MAIN ST. CULVERT REPLACEMENT

**PROJECT NO. 2023-024
BID NO. 2682**

ADDENDUM 3

July 21, 2025

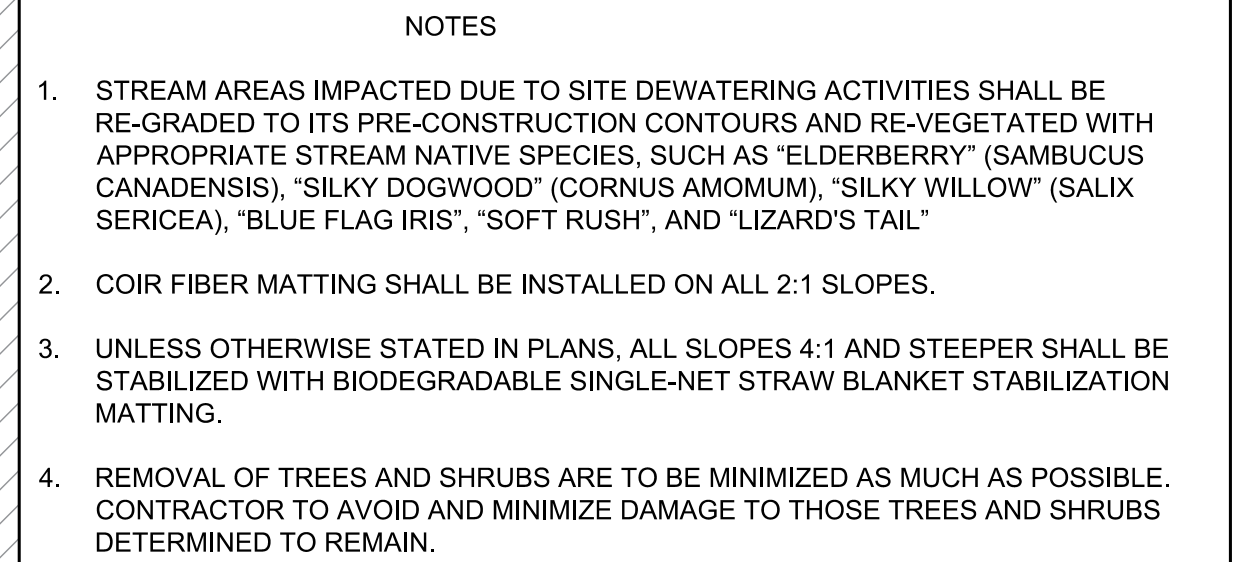
2. OVERHEAD UTILITIES OVER THE CREEK AREA:

The lines visible in the picture on the poles closest to the street are communication lines, and they will remain in place during construction. There is a power line on the same poles that feeds the streetlights, which will be removed before construction starts. The power lines in the background are Duke Energy lines and will remain in place during construction. If there is concern about this line, the successful contractor can arrange with Duke Energy to sleeve these lines, providing some level of protection.
